## Market Rule Amendment Proposal

Identification No.:	MR-00359-R00		
Subject:	Generation Facility Requirements		
Title:	Changes to Facilitate Connections		
Nature of Proposal:	<input checked="" type="checkbox"/> Alteration	<input type="checkbox"/> Deletion	<input type="checkbox"/> Addition
Chapter:	4	Appendix:	4.2
Sections:			
Sub-sections proposed for amending:

## Appendix 4.2 – Generation Facility Requirements ~~(Embedded and Non Embedded)~~

# Requirement 3

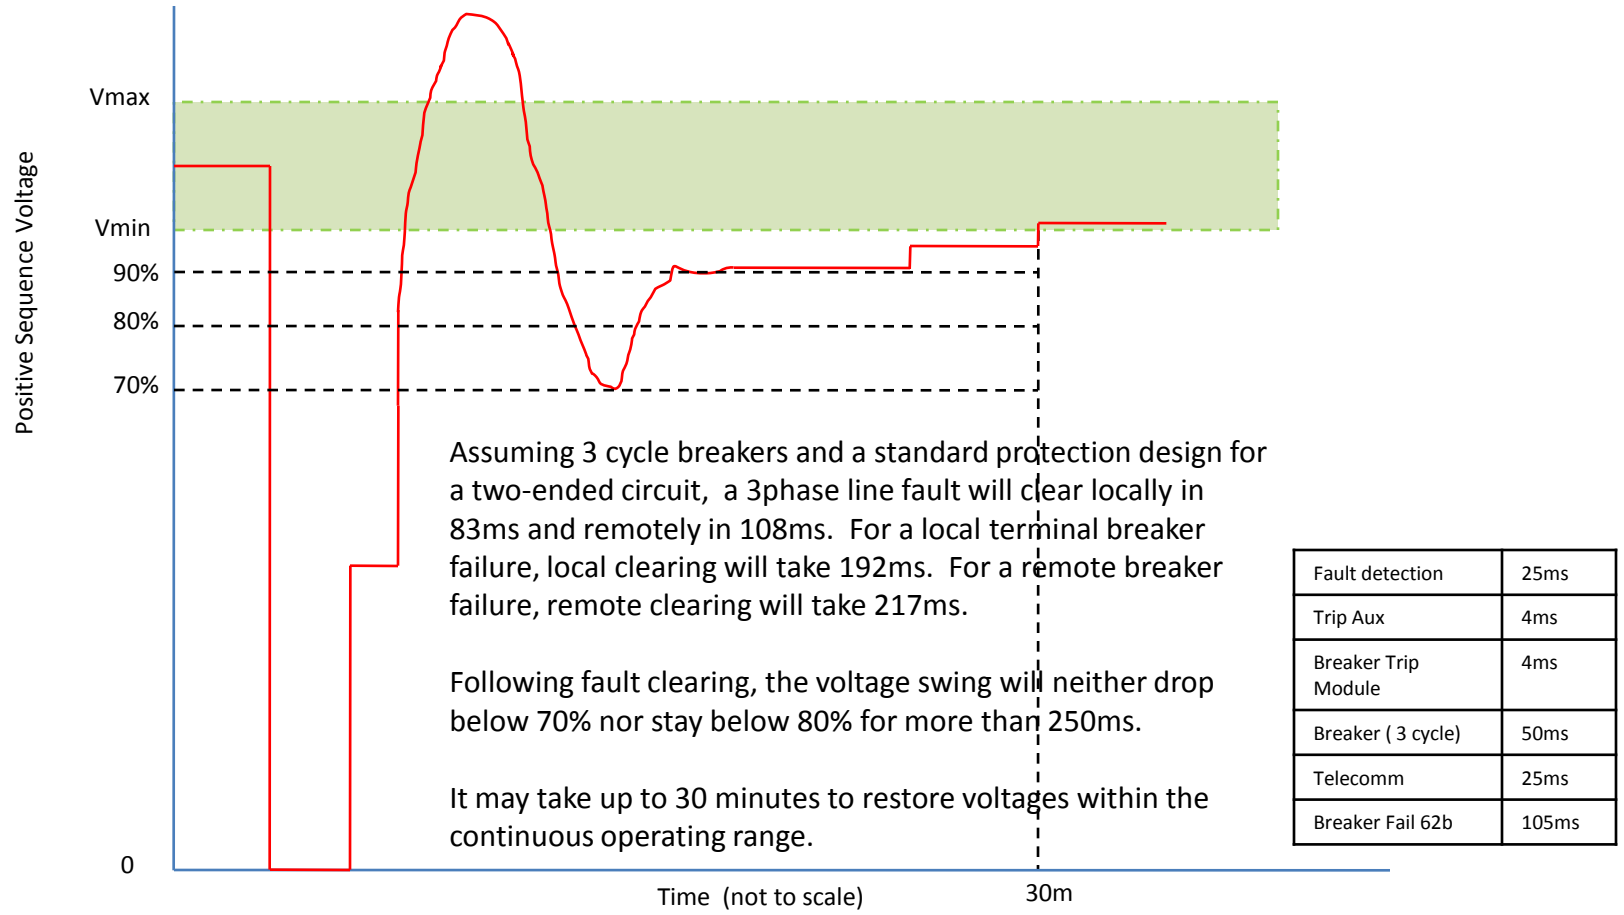
Settings on new or modified equipment should not result in out-of-zone tripping. A complete review of all downstream protection each time a change is made is not an IESO requirement . An acceptable level of confidence will result from the following process:

- No new problems may be introduced,
- All known problems must be fixed, and
- All other problems will be fixed when they become known.

# Requirement 5

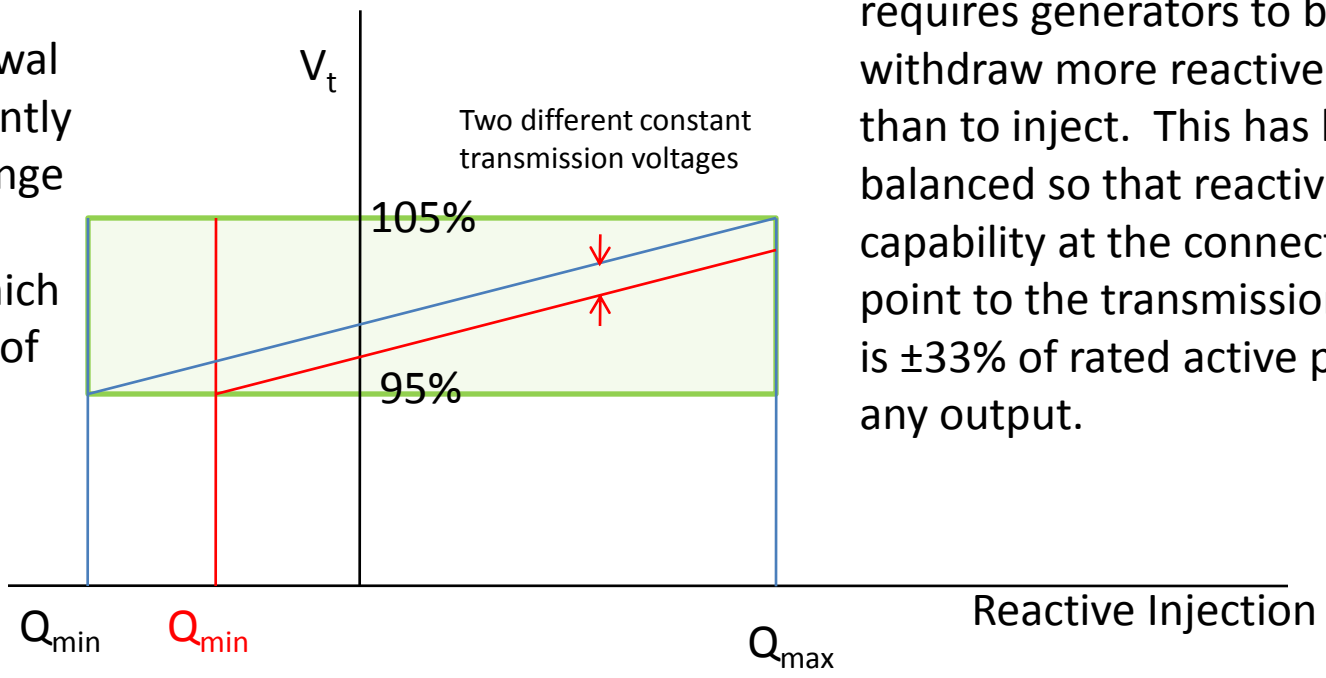
Reducing the reactive withdrawal capability inherently increases the range of transmission voltages over which the entire range of reactive can be supplied.

The present requirement requires generators to be able to withdraw more reactive power than to inject. This has been balanced so that reactive capability at the connection point to the transmission system is  $\pm 33\%$  of rated active power at any output.

A 0.90lag/0.95 lead power factor generator with a transformer impedance not larger than 13% on generator Sbase power rating would be acceptable.

## Requirement 5 (cont.)

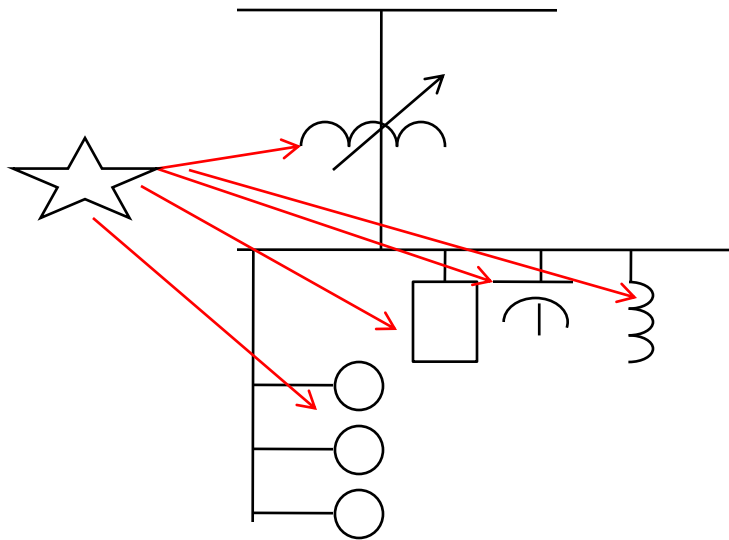
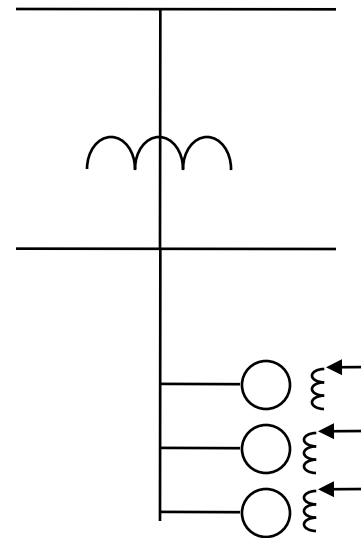
The proposed change specifies a lesser reactive capability that is continually available is permissible in some circumstances. For example, wind facilities that continue to control voltage even when there is insufficient wind to turn turbine blades will have a reduced reactive capability requirement. The advantage of having a reactive capability under windless conditions would have to be greater than the disadvantage of the reactive capacity reduction under windy conditions.

Complicated designs requiring close coordination of equipment from different vendors have arisen under the present requirements.

The rules ought to encourage designs that work better for all parties.

## Requirement 6

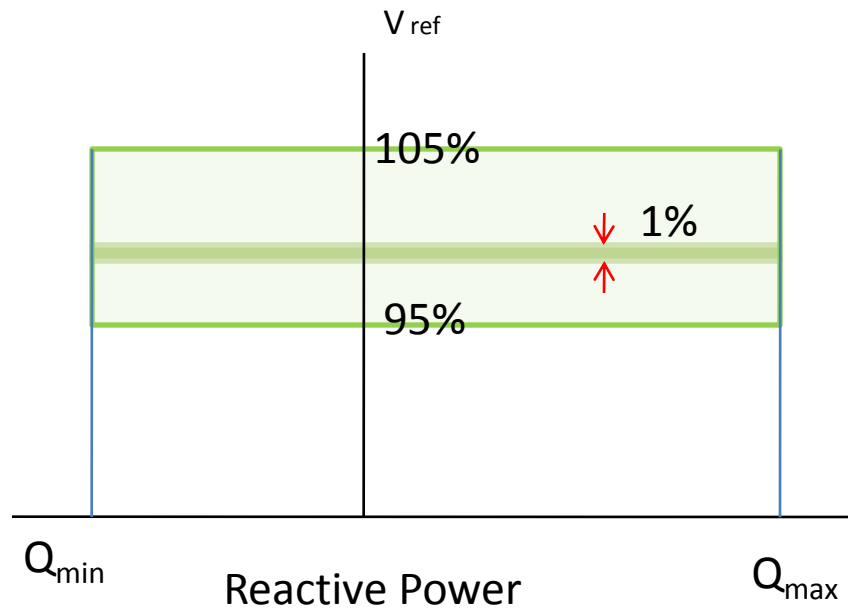
Reference voltage must be maintained within  $\pm 0.5\%$  of any set point within  $\pm 5\%$  of rated voltage. This requirement is not changed. The same requirement applies for droop systems and is captured with a minimum droop requirement.

# Requirement 7

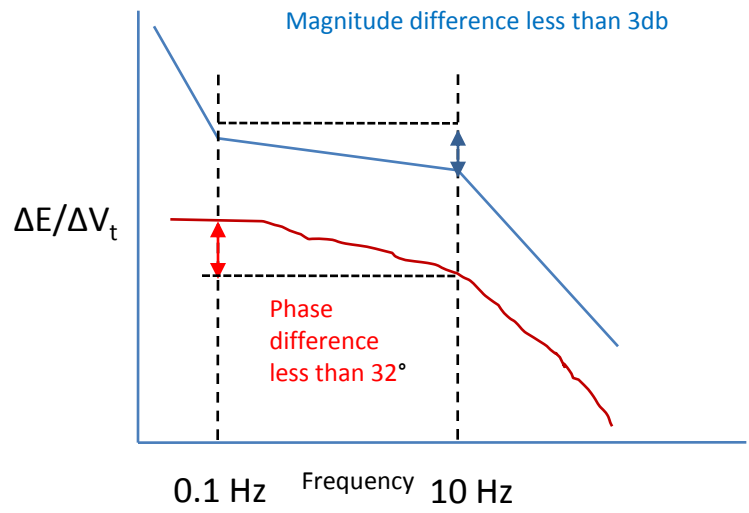
The changes to the excitation system requirements will remove uncertainty by providing measureable requirements.

A linear firing angle change in response to voltage error change will result in a non-linear exciter voltage change and this is not acceptable. The exciter gain is required to be linear.

## Requirement 9

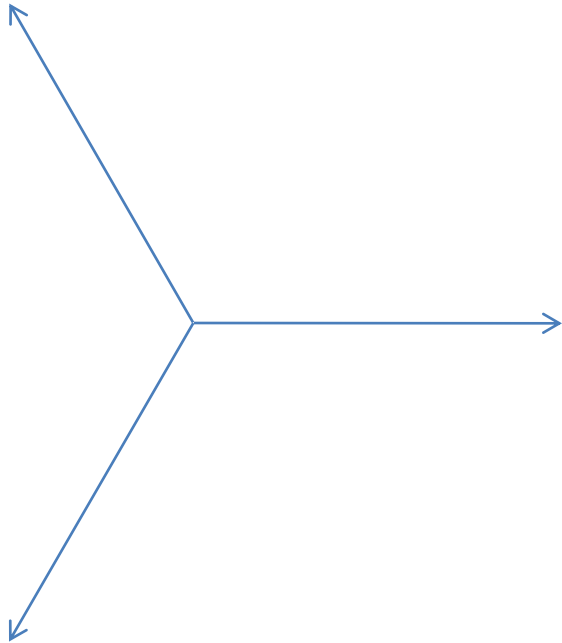
The twin requirements to produce a relatively clean waveform (e.g. shall not exceed 1% open circuit phase voltage unbalance) and to be capable of operating under less than perfect conditions (e.g. be able to continuously operate with a phase unbalance as high as 2%) are unchanged.

# Requirement 10

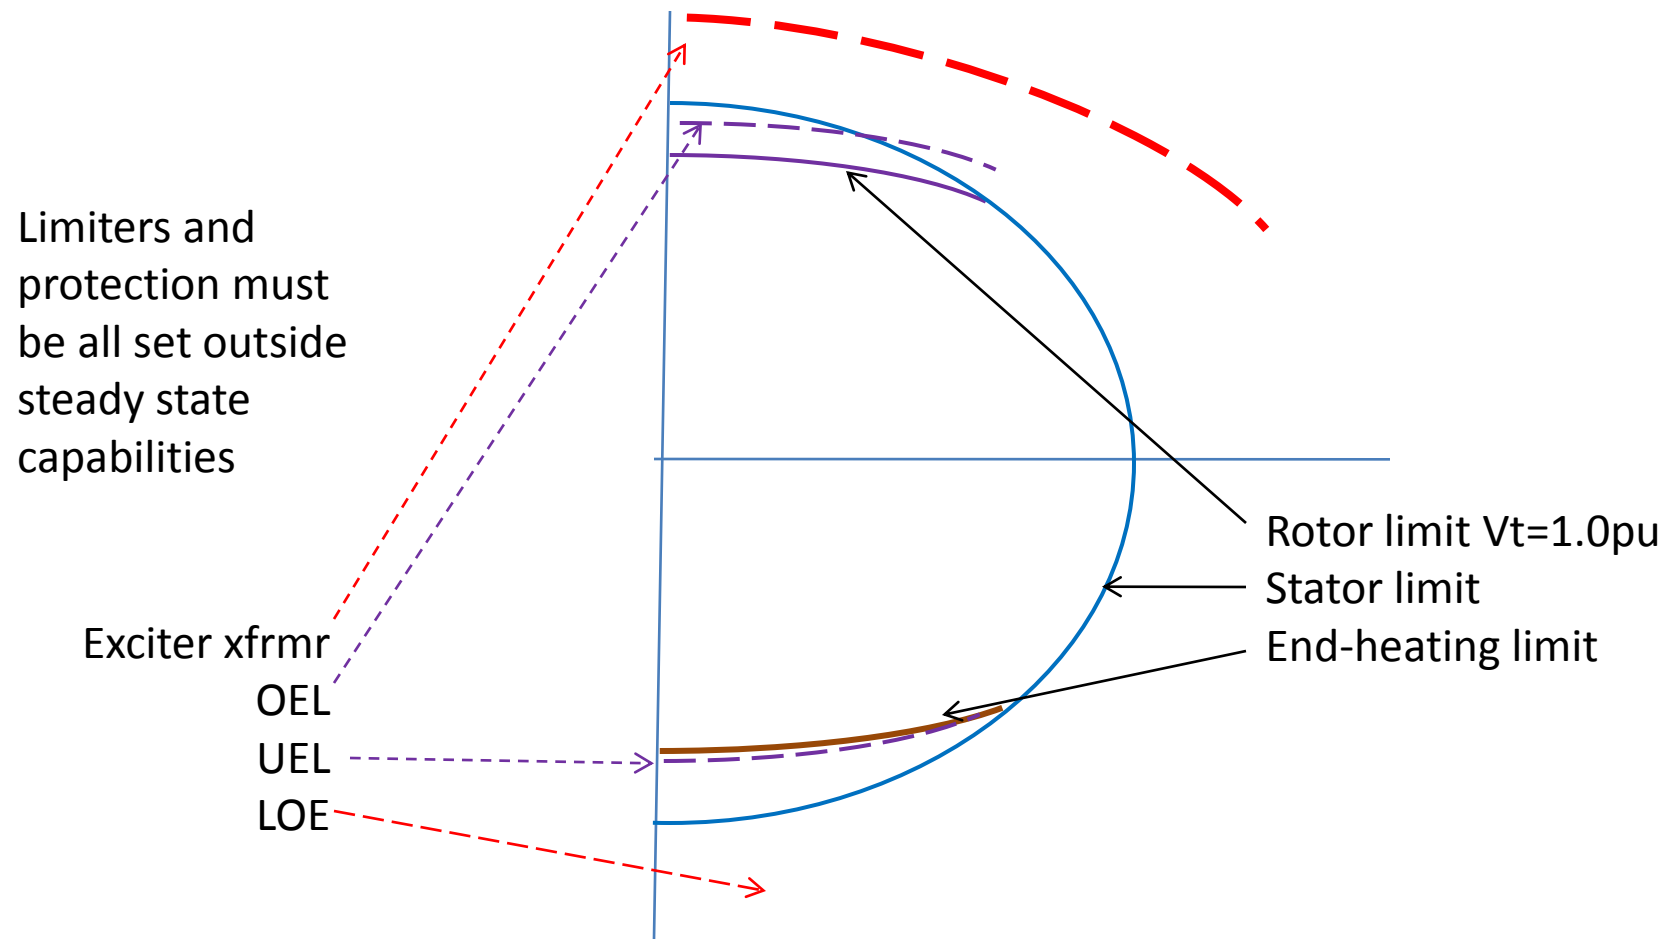
When damage can occur very quickly (e.g. end-heating on thermal units), limiters can be set as near to the steady state capability as reasonably achievable.
